Lower Thames Crossing

9.89 Responses to the Examining Authority's ExQ1 Appendix H – 12. Physical Effects of Development & Operation

Planning Inspectorate Scheme Ref: TR010032
Examination Document Ref: TR010032/EXAM/9.89

Drawing title
SOUTHERN TUNNEL ENTRANCE COMPOUND - DIAGRAMMATIC SECTION

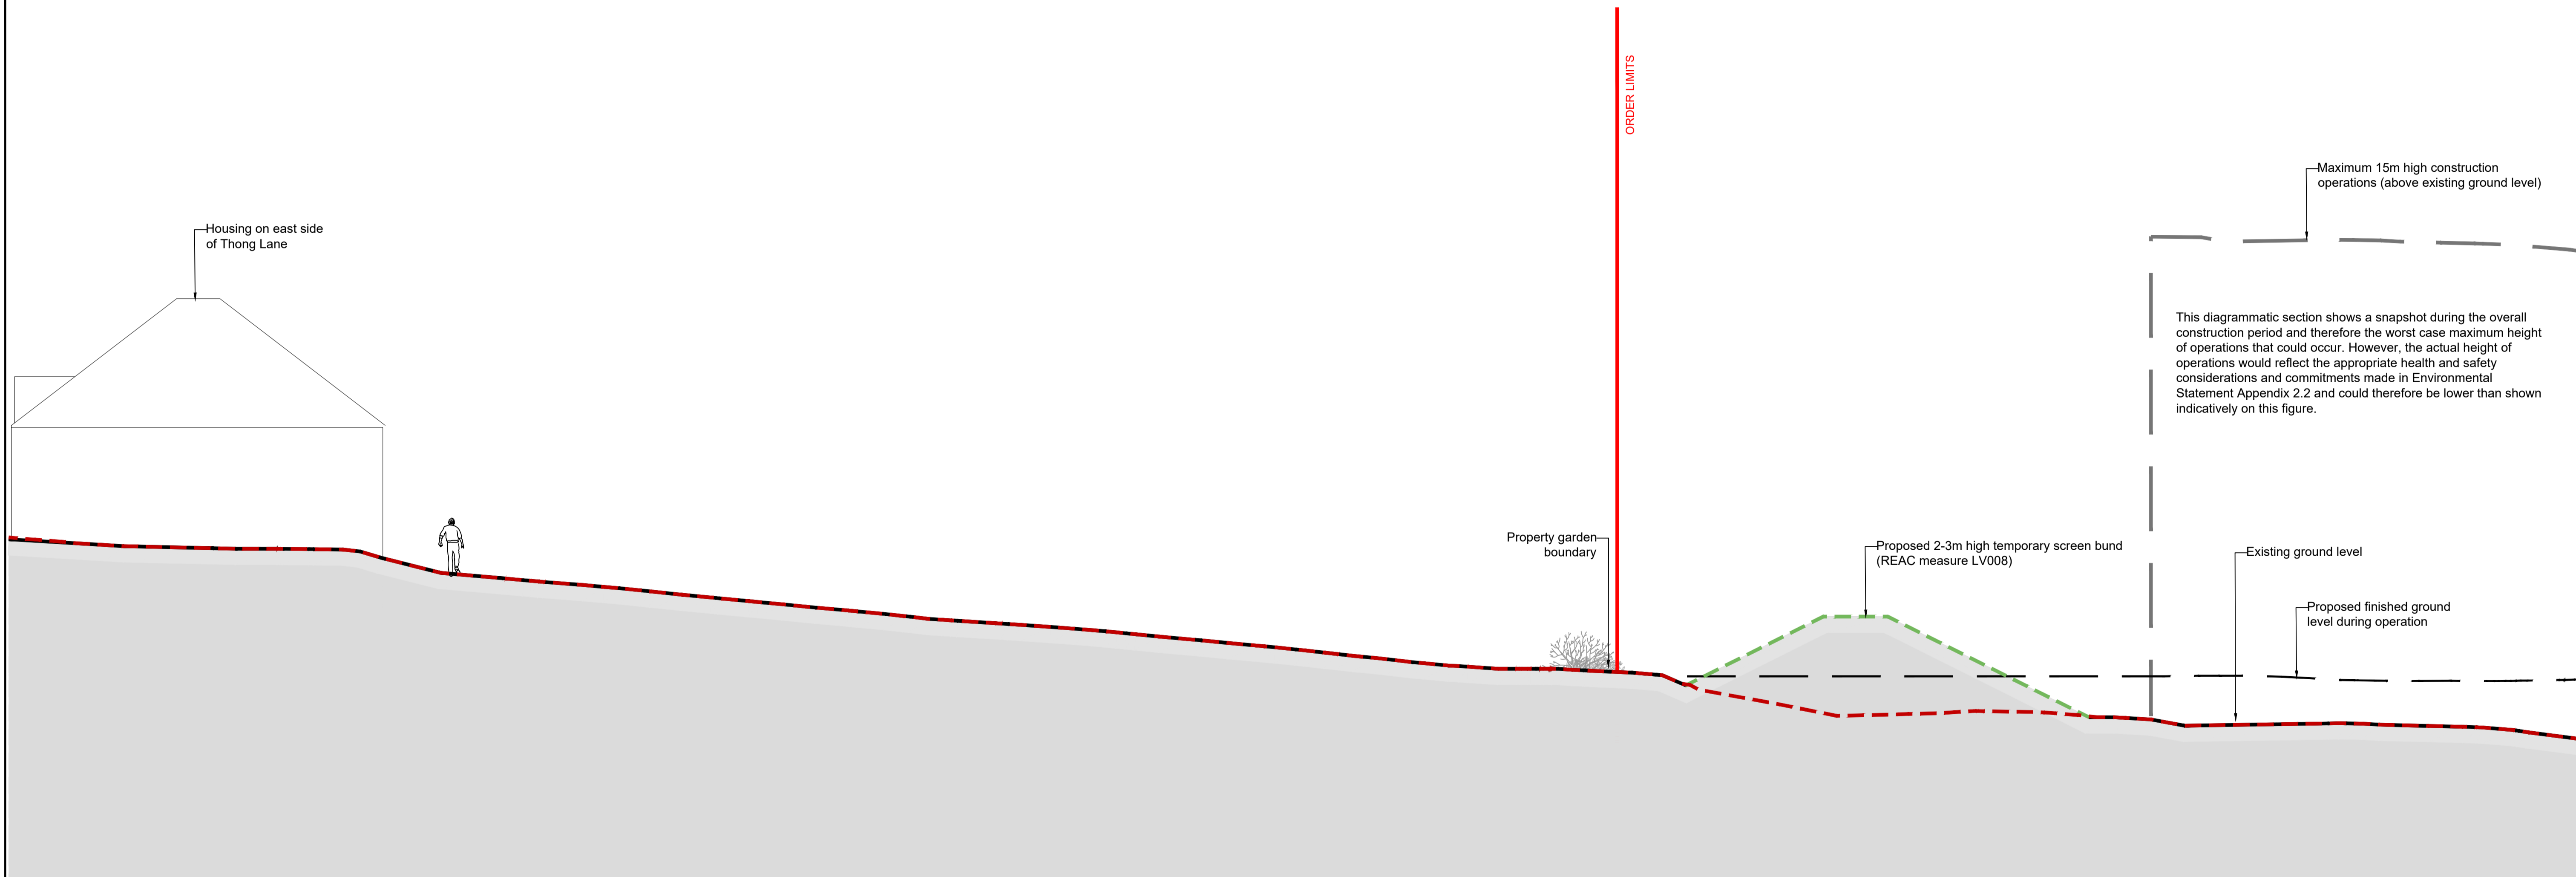
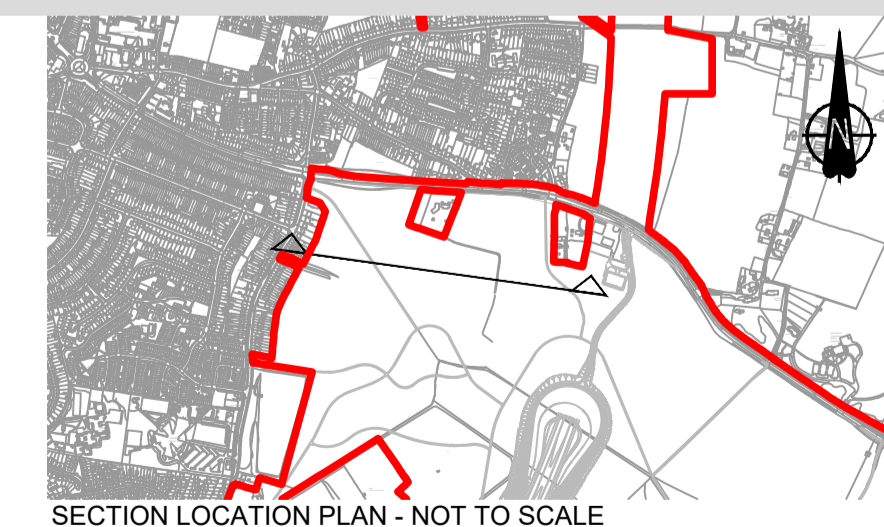
ExQ1_Q12.3.5	N/A	<p>Additional Photomontages</p> <p>Concerns have been raised by Gravesham Borough Council, the Kent Downs AONB Unit and Natural England about the visual impact of the proposed road from representative viewpoint S-03 (view from Kent Downs AONB on footpath NS161). The ExA shares those views. The Applicant shall provide photomontages for Winter Year 1 and Summer Year 15 for viewpoint S-03 or explain in explicit terms why the photomontages cannot be produced.</p>

PINS ID	External Stakeholder (where applicable)	Question / Response
		<p>Response:</p> <p>The Applicant has provided Comments on Written Representations (WRs) Appendix A: Statutory Environmental Bodies [REP2-046] and Comments on Local Impact Reports (LIRs) Appendix D: Gravesham Borough Council [REP2-058], which include responses to the issues raised on the view from Representative Viewpoint S-03 in Natural England's WR [REP1-262], the Kent Downs Area of Outstanding Natural Beauty Unit's WR [REP1-378], and Gravesham Borough Council's LIR [REP1-228]. However, the Applicant will submit new winter year 1 and summer year 15 photomontages from Representative Viewpoint S-03 at Deadline 5, to illustrate the proposed landscape design as requested.</p>
ExQ1_Q12.3.6	N/A	<p>Construction Compounds</p> <p>It is noted that Document 2.17 - Temporary Work Plans Documents Volumes B and C [AS-034 and AS-036] provide indicative layouts for the construction compounds or utility logistics hubs but these are in floorplan only with no elevations. Similarly, none of the compounds and hubs are identified in any LVIA photomontages (noting the photomontages are for operational years only). Given the potential for 6m high earth and plant storage, 15m high accommodation blocks and 25m high concrete batching plant, the layout and appearance of the compounds and hubs is important to the landscape and visual impact assessment during the lengthy construction period. The Applicant shall provide photomontages of the compounds and hubs where they are sited within 100m of residential receptors and where those compounds or hubs are expected to remain in situ for more than 18 months. The Applicant shall use the Register of Environmental Actions and Commitments Nos. LV006/ LV007/ LV010/ LV012/ LV016/ LV018/ LV019/ LV020/ LV022/ LV025/ LV027/ LV033 (contained in ES Appendix 2.2 – Code of Construction Practice, First Iteration of</p> <p>Response:</p> <p>The locations of the proposed Utility Logistics Hubs (ULHs) are shown on the Temporary Works Plans Volume B (Sheets 1 to 20) and Volume C (Sheets 21 to 49) [AS-034 and REP3-071], with indicative layouts shown in Plates 1.18 and 1.19 of Environmental Statement (ES) Appendix 2.1: Construction Supporting Information [AS-049].</p> <p>Although the photomontages in ES Figure 7.19: Photomontages – Winter Year 1 and Summer Year 15 [APP-244, REP3-102, APP-245, REP1-131, APP-246 and APP-247] only illustrate the operational phase</p>

PINS ID	External Stakeholder (where applicable)	Question / Response
		<p>of the Project, the approximate location and extent of each construction compound and ULH is annotated in blue font on Representative Viewpoint photographs in ES Figure 7.17 Representative Viewpoints – Winter and Summer Views [APP-235, APP-236, APP-237, APP-238, APP-239, APP-240, APP-241 and APP-242].</p> <p>In addition, the maximum heights of construction operations within compounds are shown on ES Figure 7.8: ZTV - 5km DTM Analysis of Main Construction Compounds [APP-204 and APP-205], where either the duration of the works exceeds five years or the proposed construction activity includes features over 15m high, as explained in paragraph 4.5.2 of ES Appendix 7.8: Technical Methodologies [AS-054]. Further information on assumed heights within construction compounds is provided in paragraph 4.5.2 of ES Appendix 7.8.</p> <p>Due to the ULHs being predominantly '<i>for the receipt, storage and distribution of plant, machinery and materials for specific utilities works</i>', as stated in Table 2.10 of ES Chapter 2: Project Description [APP-140], it is envisaged that there would be a smaller number of modular units compared to the construction compounds and all of the units would be single storey in height (assumed to be maximum 3m high).</p> <p>The above information has been used to inform the landscape and visual impact assessment in ES Chapter 7: Landscape and Visual [APP-145].</p> <p>The measures referred to by the Examining Authority in the Register of Environmental Actions and Commitments (REAC) set out in ES Appendix 2.2: Code of Construction Practice, First Iteration of Environmental Management Plan (Version 3.0) [REP3-104] relate to the following construction compounds:</p> <ul style="list-style-type: none"> • LV006: Marling Cross compound • LV007: A2 compound • LV010: Southern tunnel entrance compound • LV012: A226 Gravesend Road compound • LV016: Station Road compound • LV018: Brentwood Road compound • LV019: Stifford Clays Road compound East • LV020: Mardyke compound

PINS ID	External Stakeholder (where applicable)	Question / Response
		<ul style="list-style-type: none"> • LV022: M25 compound • LV025: Ockendon Road compound • LV027: Warley Street compound • LV033: Long Lane compound A <p>All the above construction compounds would be in place for over 18 months, but the Station Road compound, Brentwood Road compound, M25 compound, Warley Street compound and Long Lane compound A would be further than 100m from a dwelling and the Applicant does not therefore propose to prepare visualisations of these more distant compounds. Only the Long Lane ULH and the Stanford Road ULH would be both in place longer than 18 months and within 100m of a residential receptor. However, as explained above, the maximum height of these ULHs is assumed to be no greater than 3m so the visual impacts would be limited. The Applicant does not therefore propose to prepare any visualisations of ULHs.</p> <p>For the operational phase of the Project, 3D models of the outline Project design have been used to prepare photomontages in ES Figure 7.19. However, the equivalent level of information is not available for the proposed construction compounds and ULHs. This is because the exact layout of the compounds has yet to be designed and the internal layouts shown in Plates 1.1 to 1.17 of ES Appendix 2.1: Construction Supporting Information [AS-049] serve as illustrative representations. The compound layouts will be designed in accordance with the requirements of the Development Consent Order (DCO) [REP3-077] during the construction phase once the detailed design and construction methodology have been established.</p> <p>Sufficient information is therefore only available to prepare indicative visualisations to show the worst-case, maximum height, scale and massing of the proposed construction compounds. However, the Applicant does not consider indicative photomontages, for example wireline photomontages, to be the most appropriate format because Representative Viewpoints in ES Figure 7.17 have been photographed from publicly accessible viewpoints in accordance with best practice guidance in paragraph 6.16 of the Guidelines for Landscape and Visual Impact Assessment, Third Edition (GLVIA3)⁹. Furthermore, a wireline photomontage is likely to be difficult to interpret in close-range views within 100m from a residential receptor.</p>

PINS ID	External Stakeholder (where applicable)	Question / Response
		<p>By contrast, diagrammatic sections can be prepared to scale from any residential location and would illustrate the spatial relationship between a compound and adjoining residential area. The Applicant therefore proposes to prepare a series of diagrammatic construction sections, drawn to scale, showing the spatial relationship of the following construction compounds to nearby residential receptors by Deadline 5, based on the sample section provided with this response (see Figure 1). The selection below has been made because the compound:</p> <ul style="list-style-type: none"> • Is referred to in the REAC measures in ES Appendix 2.2: Code of Construction Practice, First Iteration of Environmental Management Plan, which the Examining Authority has directed the Applicant to • Would be in place for over 18 months • Would be located within 100m of a dwelling • The maximum height of construction activity would be over 3m: • LV006: Marling Cross compound, in relation to the south-eastern edge of Gravesend • LV007: A2 compound, in relation to Thong Mead and the southern edge of Thong • LV010: Southern tunnel entrance compound, in relation to the eastern edge of Gravesend • LV012: A226 Gravesend Road compound, in relation to properties along Castle Lane, Chalk • LV019: Stifford Clays Road compound East, in relation to two properties on Stifford Clays Road • LV020: Mardyke compound, in relation to Hobletts • LV025: Ockendon Road compound, in relation to The Railway Sidings travellers' site
